Access Compliance Report

Public Rights-of-Way

(Curb Ramps)

Intersection ID: 3064	Main Street: BLACK_MAPLE_AV	Cross Street: HEDGE_MAPLE_RD	Location: W
ADA ID: F22C66317317	Ramp Type: Perp	Initial Pass/Fail: Fail	Overall Compliance: No
			Severity Score: 10

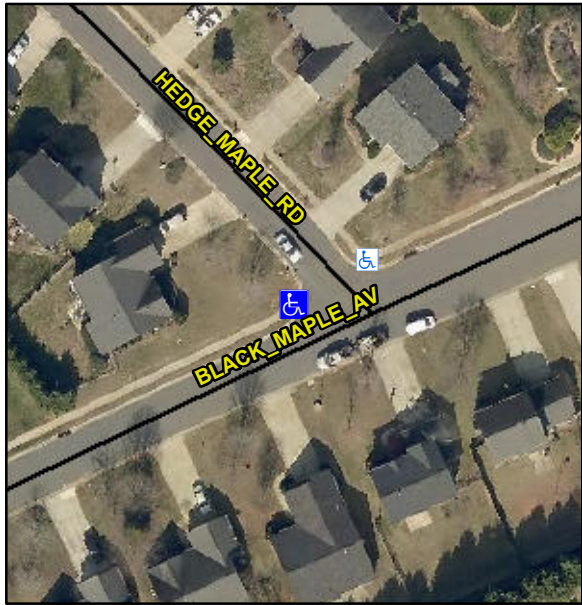
Codes/Mitigation Info/Possible Solution			Field Measurements/Component Compliance					
	Possible Solutions:		Compliance	Description	Data	Compliance	Description	Data
	Remove & Replace Entire Ramp.		N/A	Ramp Length (in)	96.5	Yes	Ramp Slope (%)	7.4
			No	Ramp Width (in)	44.0	No	Ramp XSlope (%)	2.4
			N/A	Flare Type LT	N/A	N/A	Flare Type RT	N/A
			N/A	Flare Slope LT (%)	N/A	N/A	Flare Slope RT (%)	N/A
			N/A	Flare Traversable LT?	N/A	N/A	Flare Traversable RT?	N/A
			N/A	Landing Length (in)	N/A	N/A	DWS Provided?	N/A
			N/A	Landing Width (in)	N/A	N/A	DWS Contrast?	N/A
			N/A	Landing Slope (%)	N/A	N/A	DWS Length (in)	N/A
			N/A	Landing X Slope (%)	N/A	N/A	DWS Full Width?	N/A
Surveyor Notes:		N/A	N/A	Landing Curb? (Y/N)	N/A	N/A	DWS Offset (in)	N/A
PROW/ADA:		R304.5.1, R304.5.3	N/A	Shared Landing?	N/A			
			N/A	Gutter Ponding?	N/A	N/A	Gutter Slope (%)	N/A
			N/A	Gutter Lip Ht (in)	N/A	N/A	Gutter X Slope (%)	N/A
			N/A	Painted X Walk1?	No	N/A	Painted X Walk2?	N/A

X Walk 1 Direction	To NE		X Walk 2 Direction	N/A
			N/A	X Walk 1 Width (in)	N/A	N/A	X Walk 2 Width (in)	N/A
				X Walk 1 Slope (%)	3.7		X Walk 2 Slope (%)	N/A
				X Walk 1 X Slope (%)	0.6		X Walk 2 X Slope (%)	N/A
			N/A	Ramp inside XWalk1?	N/A	N/A	Ramp inside XWalk2?	N/A
				Road Slope (%)	N/A	N/A	Clear Space?	N/A
				Road X Slope (%)	N/A	N/A	Clear Space to XWalk (in)	N/A
			N/A	Any Obstructions?	N/A	N/A	Storm Grate/Utility Hazard?	N/A
				Obstruction Type			Storm Grate/Utility Type	
					N/A			N/A
						Yes	Surface Condition? (G/P)	Good
